**Addendum No. 1
To
Specifications
For Project No. ENG2403734214**

Description: CULVERT REPLACEMENT/REPAIR

Location: OUABACHE STATE PARK

FOR AGENCY: Department of Natural Resources

ATTACHMENT 1
SUE Information at Culvert #1

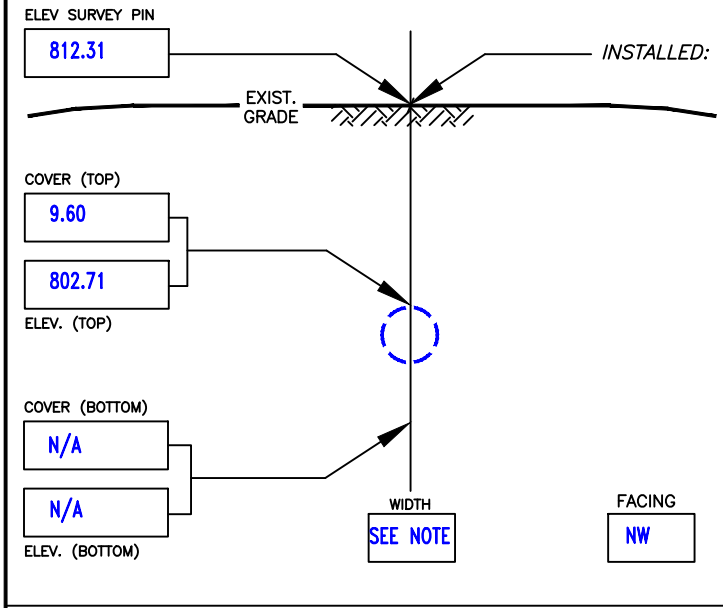
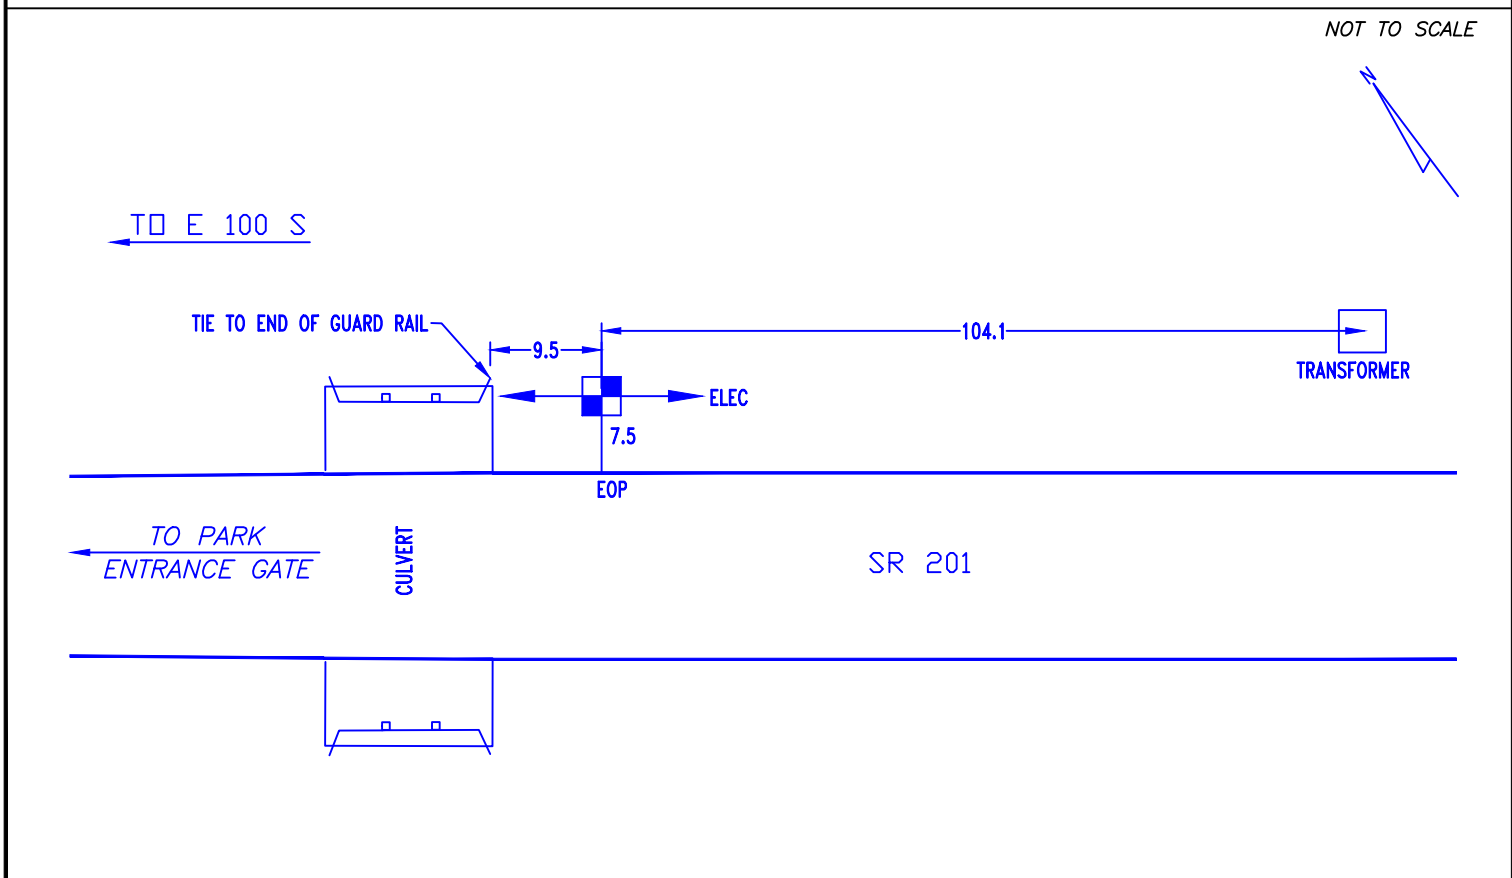
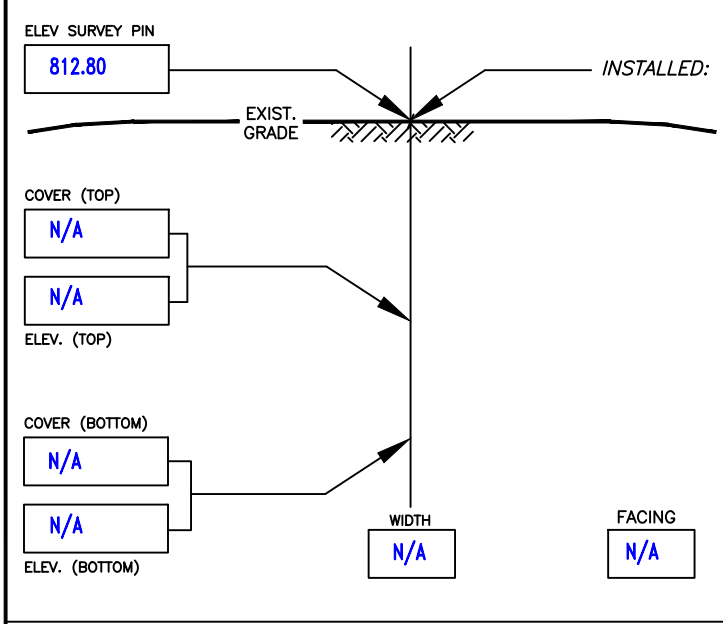
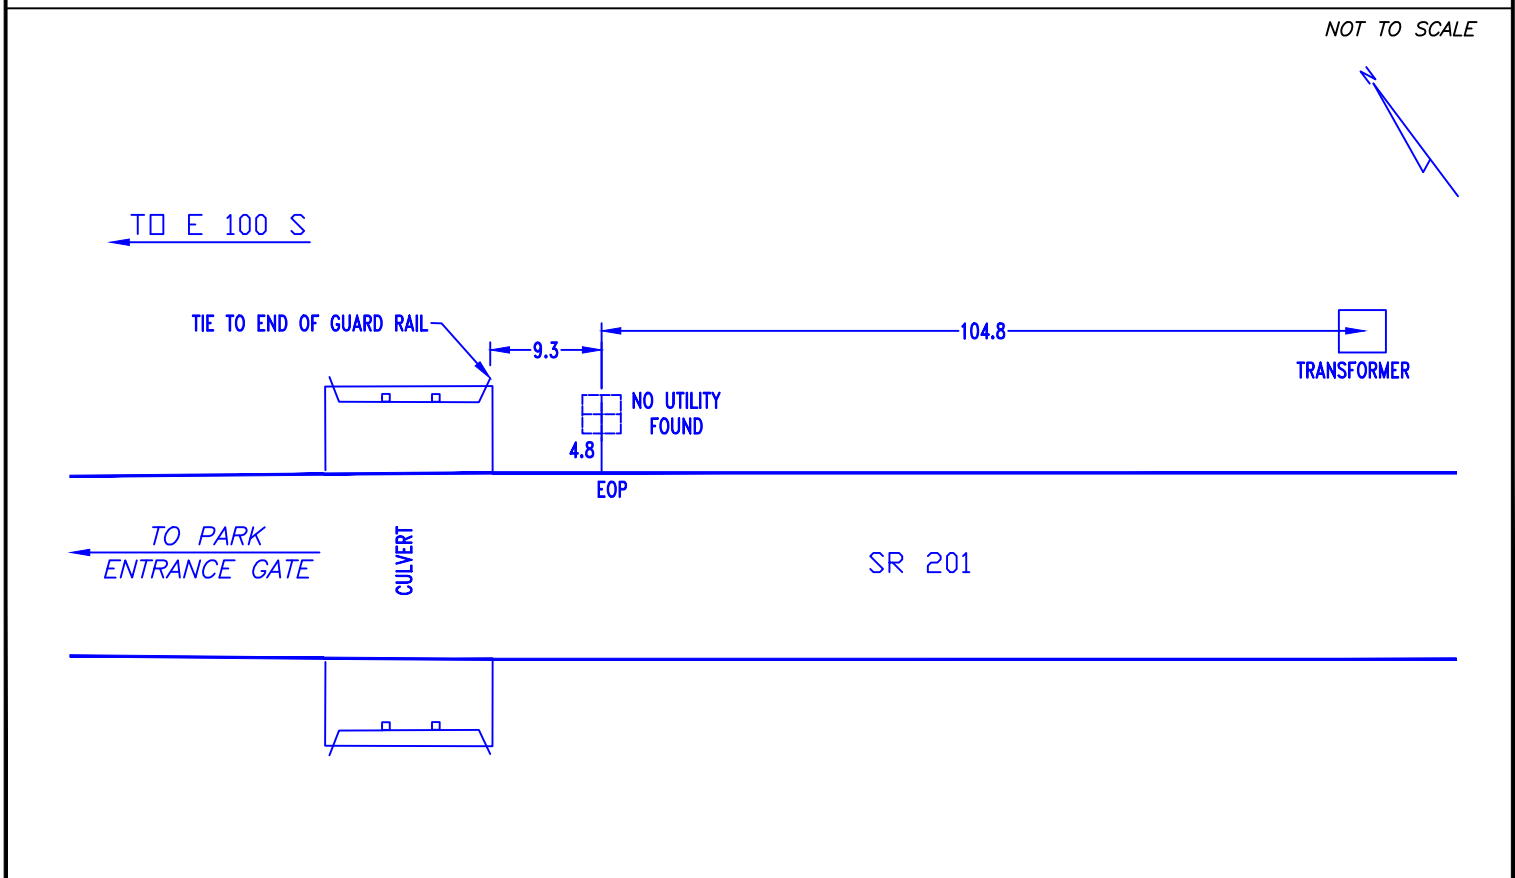
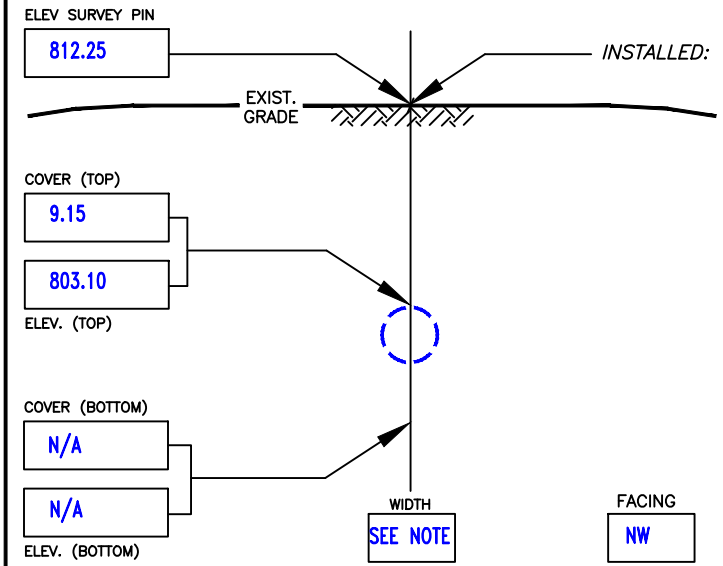
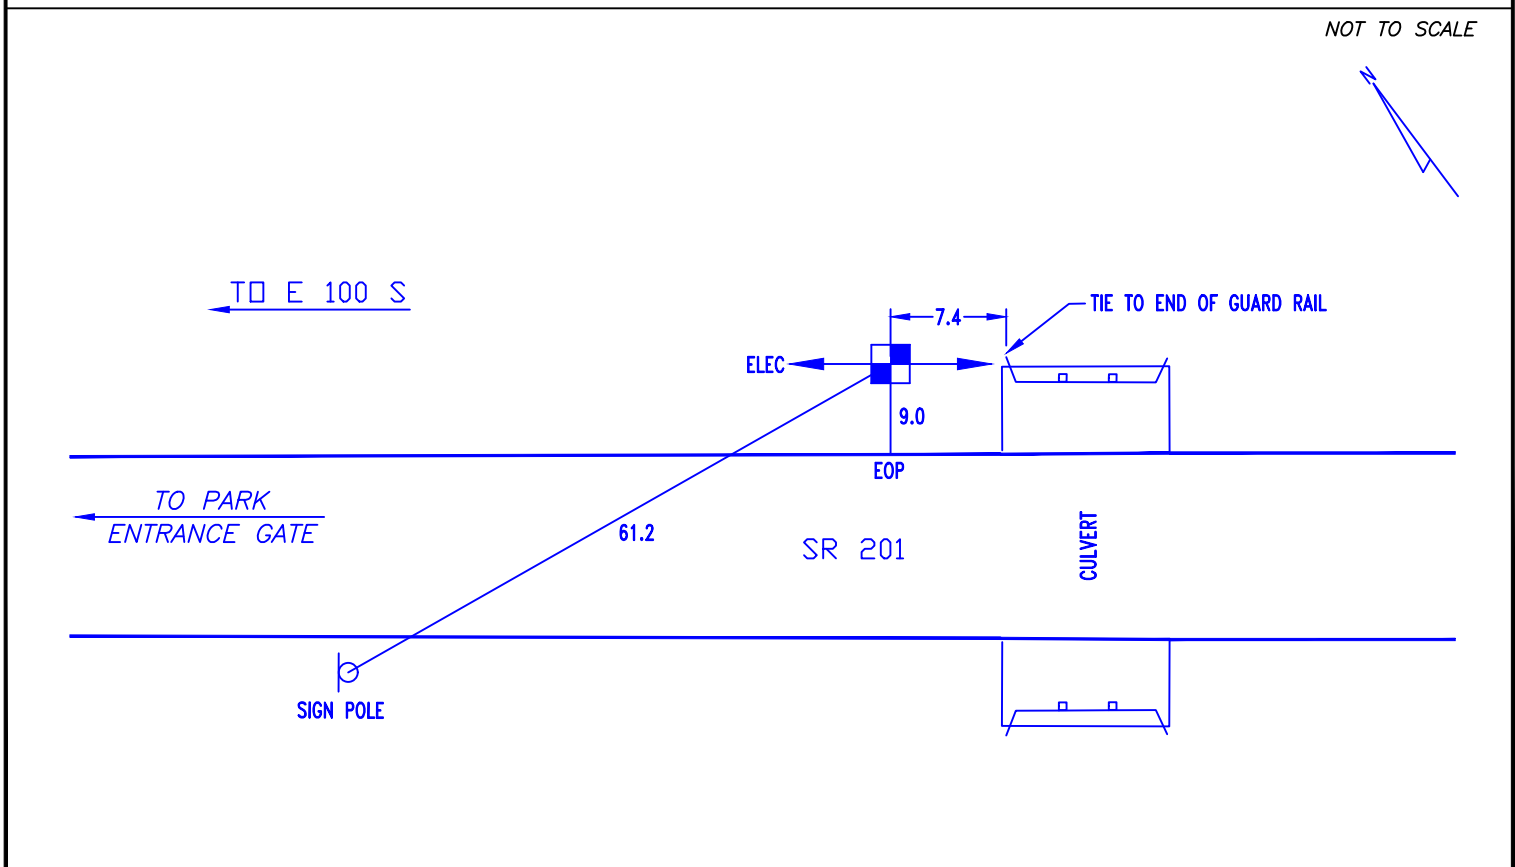
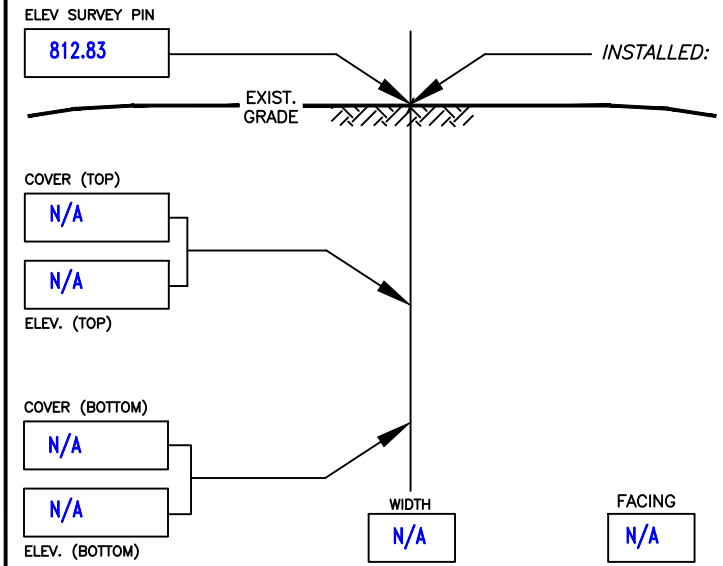
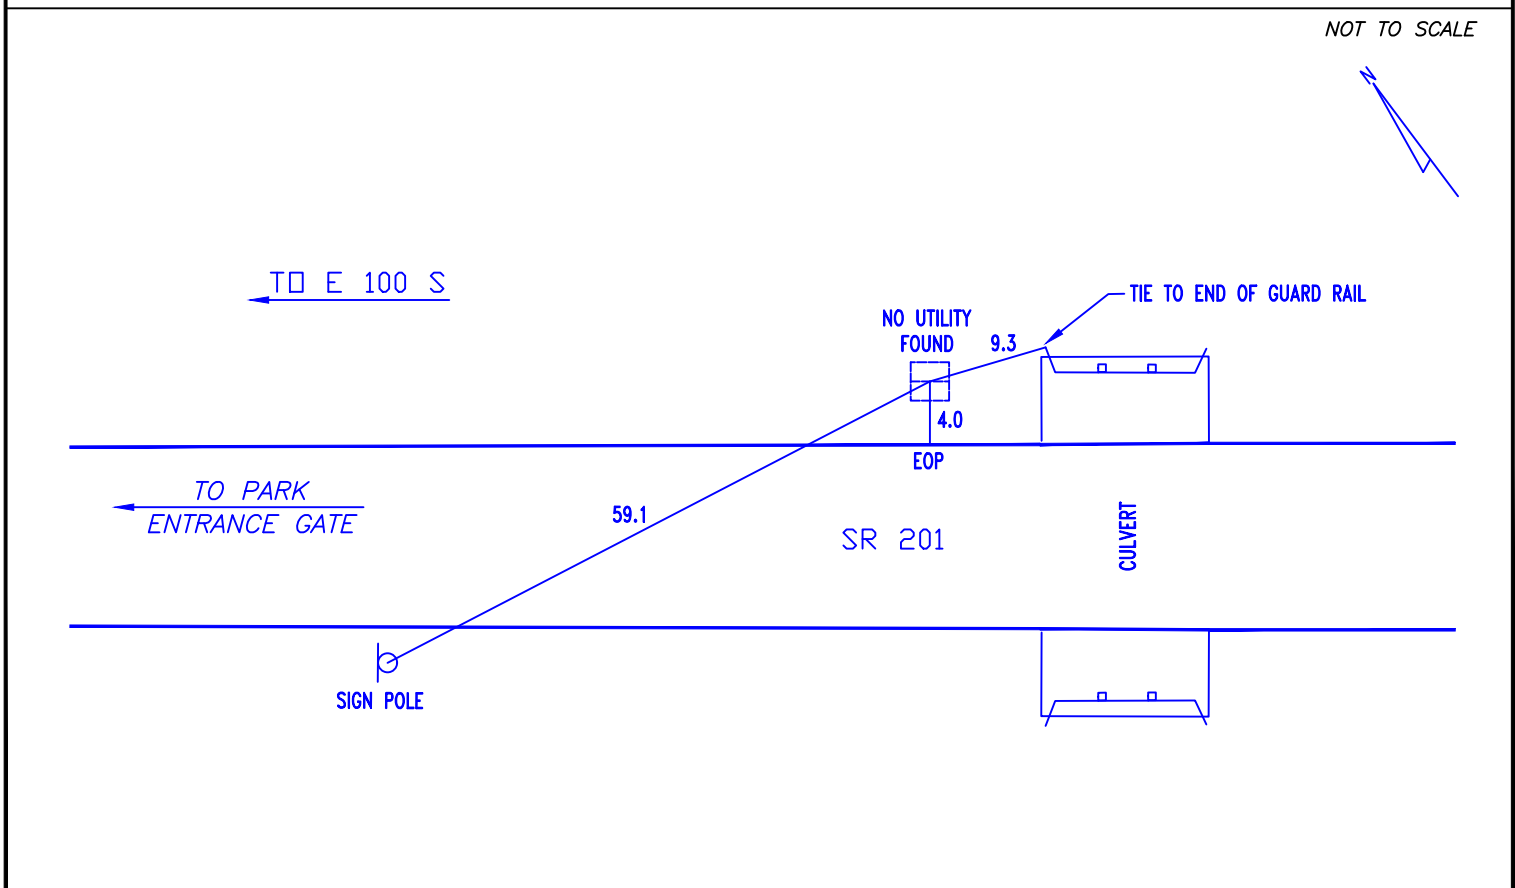
ITEM No. 9 - Subsurface Utility Engineering (SUE) Information:

Answer: SUE information was collected at Culvert #1 only. See Attachment 1. The depths of utilities are expected to be similar at Culvert #2.

Chain Link Gate (INDOT Standard Drawing E 603-CLTF-03)

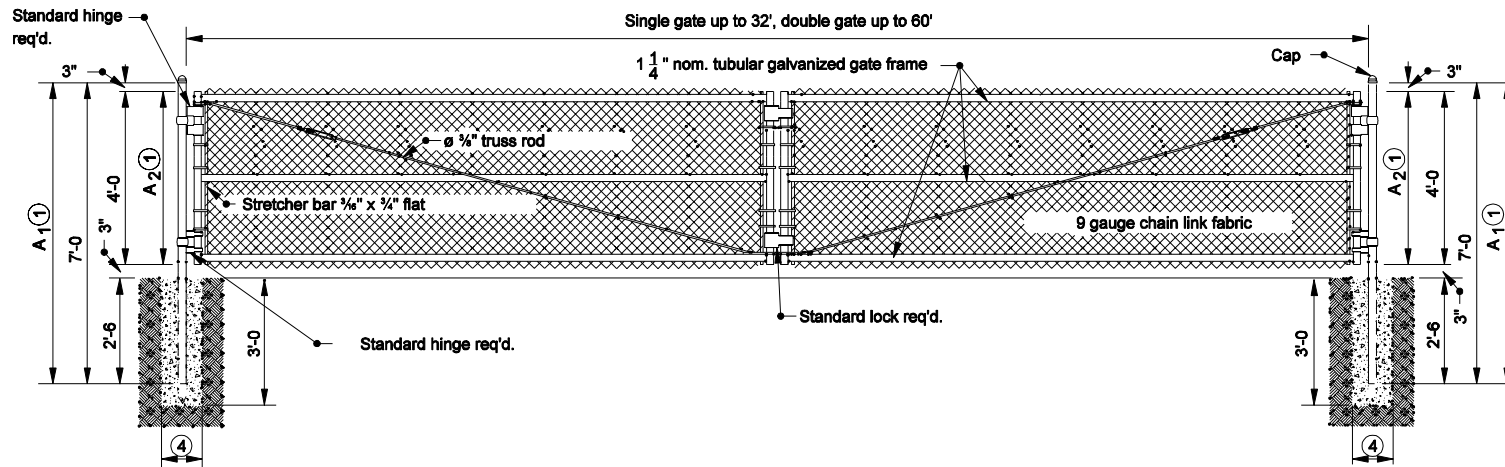
ITEM No. 10 – Chain Link Gate for Temporary Access Road:

Answer: The existing 16' gate to access Wenger Court will need to be removed and replaced. The proposed gate shall be double gate with a 24' opening (2 x 12' gates) centered on the Temporary Access Road as per

INDOT Standard Drawing E 603-CLTF-03. See Attachment #2. IDNR desires to retain the existing gate and the Contractor shall provide to the Property Manager.
